## **THOMAS MILLER ESTATES SUBDIVISION**

APPLICATION NUMBER 20 DATE July 15, 2004

REQUEST Subdivision

# THOMAS MILLER ESTATES SUBDIVISION

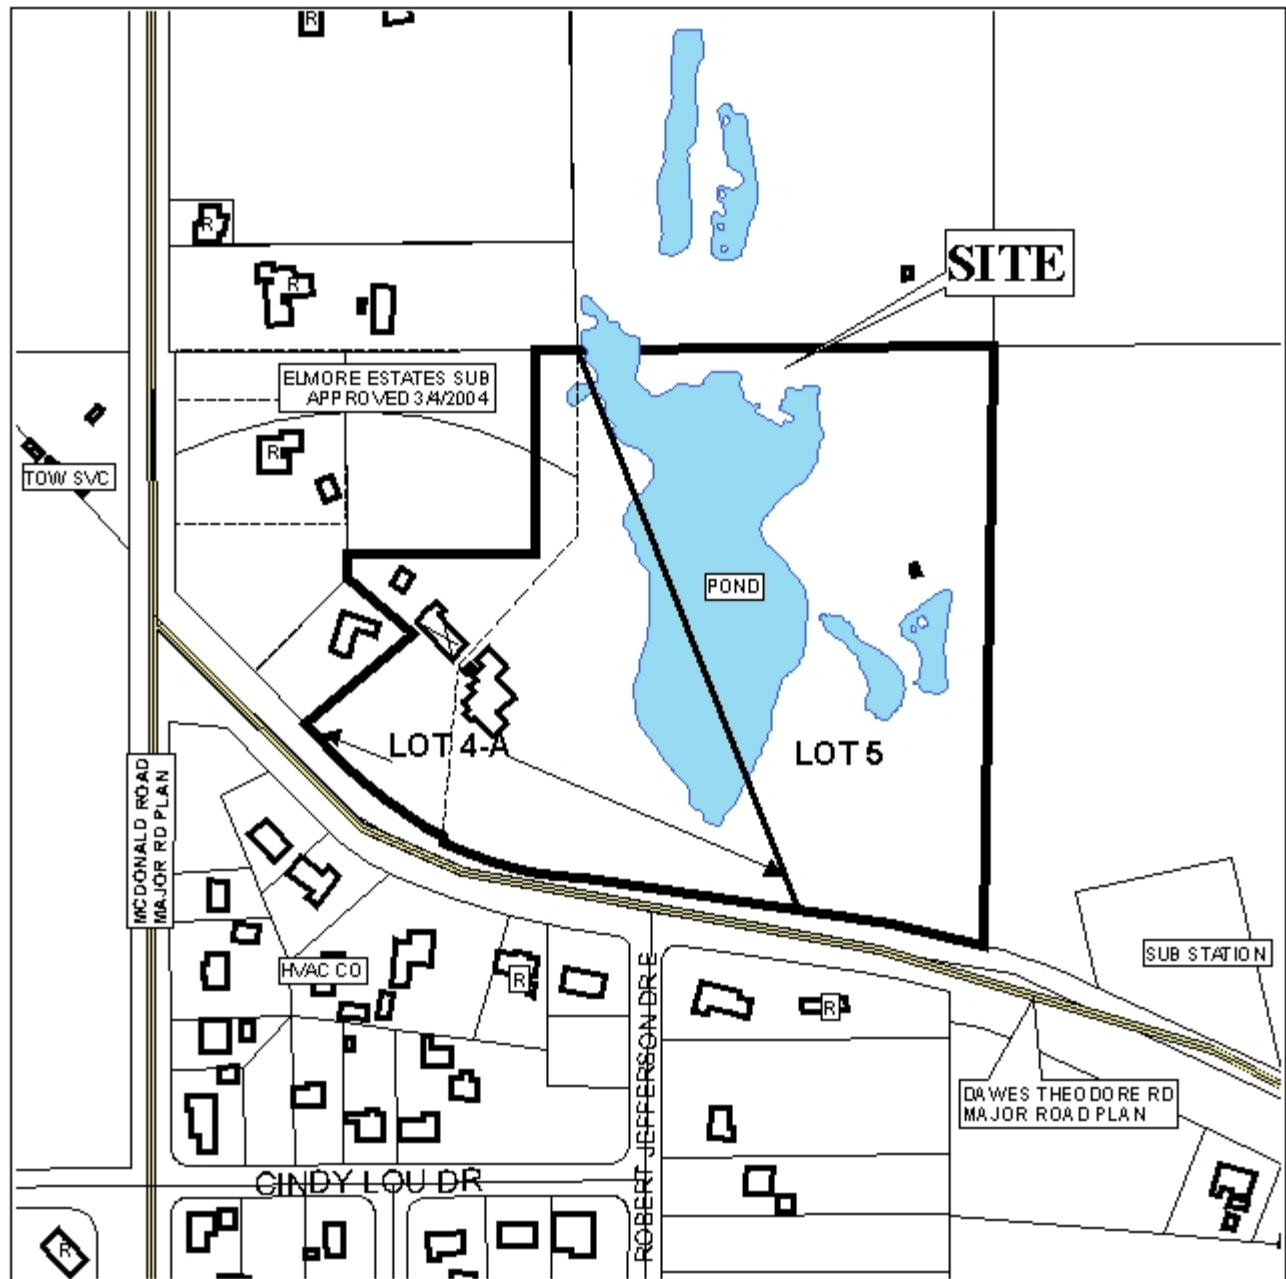
The site fronts Theodore Dawes Road, which has a variable right-of-way and is shown as a major street on the Major Street Plan, and as such requires a 100-foot right-of-way. Therefore, the dedication of adequate right-of-way to provide 50-feet from the centerline should be required. Additionally, as a means of access management, a note should be placed on the final plat stating that both lots are limited to one curb cut each, with the size, location and design to be approved by County Engineering, should be required.

Lot 5 exceeds the maximum width to depth ratio as recommended by the Subdivision Regulations; therefore, a waiver of Section V.D.3. would be required.

The 25-foot minimum building setback lines are not shown but would be required on the final plat.

The site contains numerous water features and as such the area could be considered environmentally sensitive; therefore, the approval of all applicable federal, state and local agencies would be required.

With a waiver of Section V.D.3. (width to depth ratio), the plat will meet the minimum requirements of the Subdivision Regulations and is recommended for Tentative Approval subject to the following conditions: 1) the dedication of sufficient right-of-way to provide 50-feet from the centerline of Theodore Dawes Road; 2) the placement of a note on the final plat stating that both lots are limited to one curb cut each, with the size, location and design to be approved by County Engineering; 3) the placement of a note on the final plat stating that any lots which are developed commercially and adjoin residentially developed property must provide a buffer, in compliance with Section V.A.7. of the Subdivision Regulations; 4) the placement of the 25-foot minimum setback lines on the final plat; and 5) the approval of all applicable federal, state and local agencies.
